Access Compliance Report Public Rights-of-Way (Curb Ramps)

Main Street: PERDIDO_ST Cross Street: HARRIET_LN Location: NE

ADA ID: RPRK210923111531 Ramp Type: Type 1 - Perpendicular Diagonal Initial Pass/Fail: Fail Overall Compliance: No Severity Score: 32

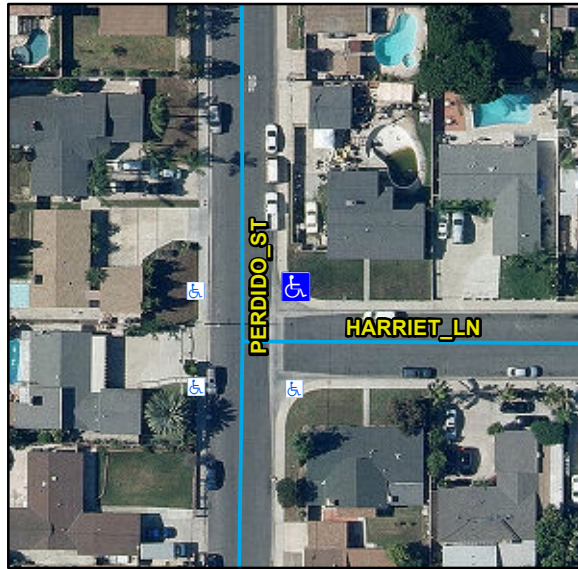
Compliance	Description	Data	Compliance	Description	Data
N/A	Ramp Length (in)	48	N/A	Flare Type LT	
Yes	Ramp Width (in)	48			N/A
No	Ramp Run Slope (%)	14.4	N/A	Flare Slope LT (%)	N/A
Yes	Ramp Cross Slope (%)	0.6	N/A	Flare Traversable LT	N/A
N/A	Landing Present	N/A	N/A	Flare Type RT	
N/A	Landing Length (in)	N/A			N/A
N/A	Landing Width (in)	N/A	N/A	Flare Slope RT (%)	N/A
N/A	Landing Run Slope (%)	N/A	N/A	Flare Traversable RT	N/A
N/A	Landing Cross Slope (%)	N/A	N/A	DWS Provided	N/A
N/A	Landing Movement Obstructed?	N/A	N/A	DWS Contrast	N/A
	Landing Movement Type	N/A	N/A	DWS Length (in)	N/A
N/A	Landing Shared	N/A	N/A	DWS Full Width	N/A
N/A	Clear Space	Yes	N/A	DWS Offset Left (in)	N/A
N/A	Clear Space To Crosswalk (in)	N/A	N/A	DWS Offset Right (in)	N/A
N/A	Marked Crosswalk 1	No	N/A	Marked Crosswalk 2	No
	Crossing 1 Direction	W		Crossing 2 Direction	S
	Marked Crosswalk 1 Width (in)	N/A		Marked Crosswalk 2 Width (in)	N/A

N/A	Ramp Inside Crosswalk 1	N/A	Yes	Ramp Inside Crosswalk 2	N/A
	Crossing 1 Slope (%)	0.5		Crossing 2 Slope (%)	0.5
	Crossing 1 Cross Slope (%)	8.2		Crossing 2 Cross Slope (%)	5.9
N/A	Gutter Ponding	N/A	N/A	Curb Slope	2.6
No	Gutter Lip Height (in)	1		Road Run Slope (%)	0.5
N/A	Gutter Run Slope (%)	N/A		Road Cross Slope (%)	0.8
N/A	Gutter Cross Slope (%)	N/A			
Yes	Overall Surface Condition: Acceptable		No	Perp Joint Present	No
	Cross Gutter Present?	Yes		Spandrel Present?	Yes
	Replace Cross Gutter?	No		Replace Spandrel?	No

Remove & Replace Curb Ramp With Two New Directional Ramps or Equivalent. Grind Gutter Lip.
